# Barangaroo Concept Plan Modification 8 and State Environmental Planning Policy Amendment (Barangaroo) 2015

MP06\_0162 MOD 8

Submission to NSW Planning and Environment  
2 May 2015

**City of Sydney**

**Figure 7. Waterfront address, MOD 4 compared to MOD 8**  
Source: VirtualIdeas/JBA

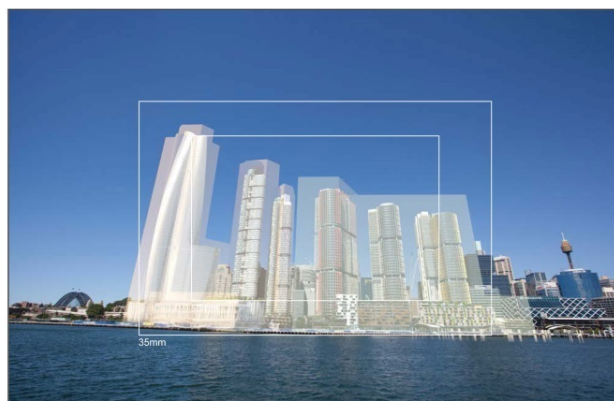
Incrementally increasing building heights towards the north (culminating in the casino/hotel building) is contradictory to historical planning principles for the Sydney CBD, introduced in the ground-breaking 1971 Strategic Plan, and is not supported. Where once there was gradual transition from higher Barangaroo building envelopes at the south to lower scale at the north, MOD 8 presents as a clear reversal of the evenly graded built form.

There are poor arguments in the planning report lodged with MOD 8 that the casino/hotel block's relocation from over the harbour to the waterfront open space demands a much taller envelope than currently approved and permitted, else the future building would lose "landmark" quality. Merely by siting it forward of every other tall building in the precinct, on land reserved for open space, "landmark" attributes are artificially and unreasonably generated and without the need for additional height and high earning floor space.

The combined effect of Block Y and Block 4A is to present a "wall" of development when viewed from the west at Balmain East and White Bay.

The hotel tower features a bulky base taking up an area the size of an urban block. This rather unappealing base dominates the entire western waterfront, the north-eastern parkland and the eastern street frontage.

The casino/hotel tower should be set within Barangaroo commercial tower backdrop within the land zoned for development rather than in the prohibited public open space zone. The retention of the depth of Globe Harbour will help achieve the desired waterfront address to the relocated podium and tower.

The large podium base of casino/hotel tower should be shrunk to fit the development potential outcomes. Building envelopes should be reduced in size to correspond to the developed designs for Block Y (hotel/casino) and Blocks 4A and 4B (residential towers), discouraging yet further increases in GFA and height, robbing the majority of the western CBD of shared western harbour views often needed to incentive redevelopment of redundant building stock.

Figure 8. Block definition comparison, MOD 4 to MOD 8

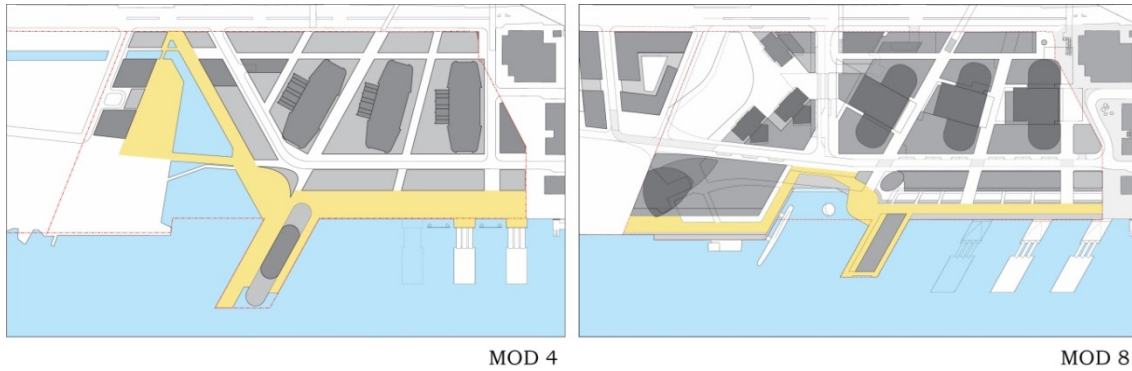
Reconfiguration of the shoreline has effectively changed the radial structure of the master architect's original design intent (Rogers et al). The proposed modification is in essence a new design that does not possess the same design approach when compared to the current Concept Plan.

Globe Street, the main access from Hickson Road penetrates too deep into the waterfront by narrowing the promenade to size of a footpath.

Incorporation of water in the Concept Plan has significantly been marginalised. The Globe Harbour inlet is currently *the* key public place in Barangaroo South. Under MOD 8 the Concept Plan will lose the significance of this valuable waterfront built-edge and the public open space. The opportunity to transform the precinct into a signature public waterfront development would be rationalised. The waterfront plaza has been reduced to the extent that seems no longer sufficient to support the scale of surrounding development. The bulk of the northern end of the plaza is dedicated to a single use of casino/hotel podium frontage and has lost potential for a multi-layered fine grain expression.

Alternative design approaches are recommended to reconfigure the shoreline that could support the original master plan design principles. A deeper cove of water, as is within the existing Concept Plan, is required.

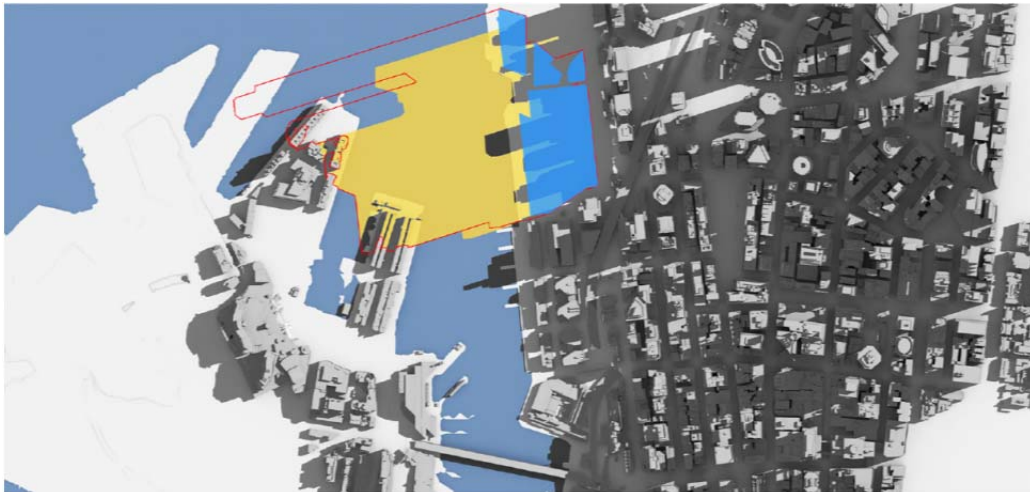
View 5 demonstrates that the proposed increase in the permissible height for the casino/hotel tower by 105 metres (to 275 metres). This combined with the proposed relocation of the building to the north of the residential towers results in adverse impacts upon views from the heart of Millers Point at the corner of High Street and Millers Point, owing to an increase in the proximity of the towers and an increase in bulk and scale

View 7 should be amended to indicate the full height of the proposed towers as viewed from Observatory Hill.

Barangaroo South Concept Plan Amendment (Mod 8) - SEPP Block Shadow Study 21st March, 9am

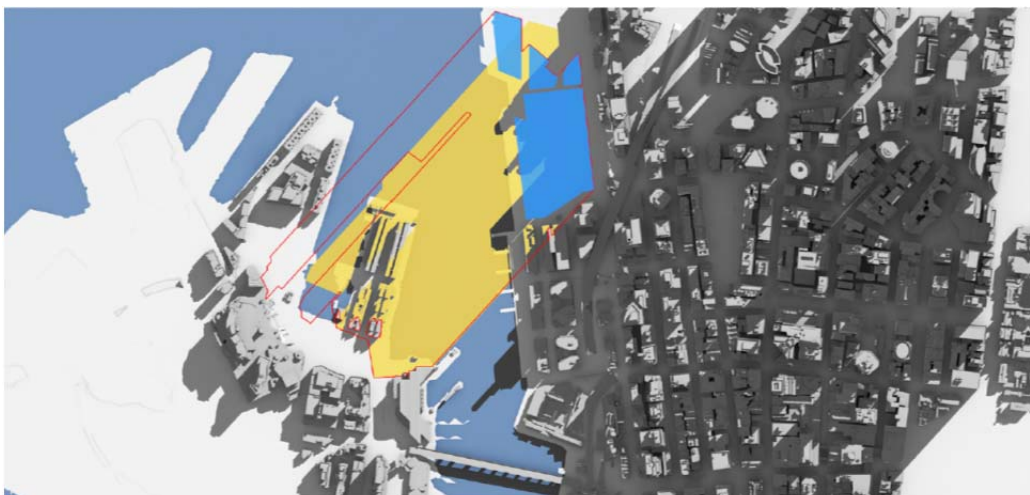
The shadow studies submitted with MOD 8 indicate that the heritage item, Jones Bay Wharf, will be partly overshadowed from the autumn equinox through to the spring equinox, in the hours around 9am. Much of the water surface of Darling Harbour will also be in shadow from the autumn equinox through to the spring equinox, in the morning hours.
